R22 SERVICE BULLETIN SB-123

R44 SERVICE BULLETIN SB-118

R66 SERVICE BULLETIN SB-44

SUBJECT: Main Rotor Teeter Hinge and Coning Hinge Bolts — Storage and Inspection

Figure 1

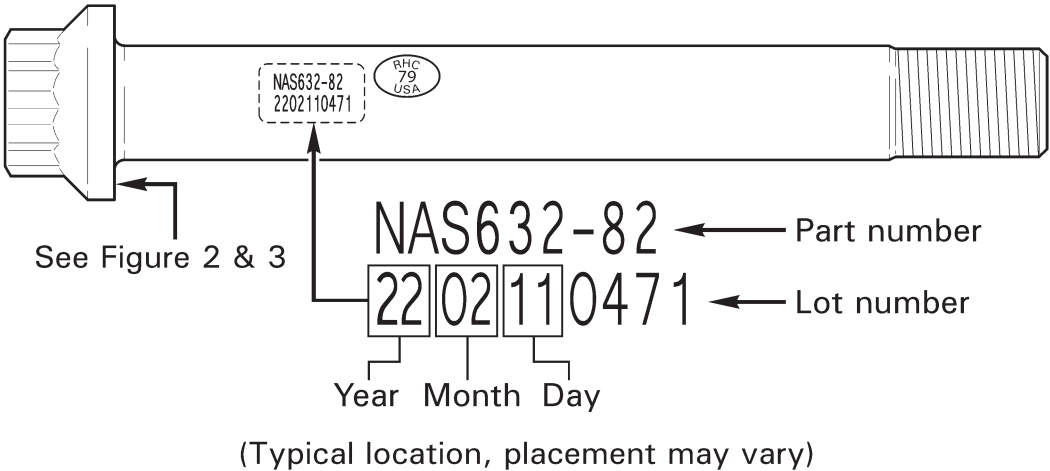
1. Refer to Figure 1, determine bolt's date code from the lot number ink-stamped on bolt shank. Bolts that have 2020 or older date codes, or if date code cannot be determined, do not install.
2. For bolts that have 2021 or newer date codes, visually inspect for corrosion or blistered cadmium plating using 10X magnification. Do not install any bolt showing corrosion or blistered cadmium plating.
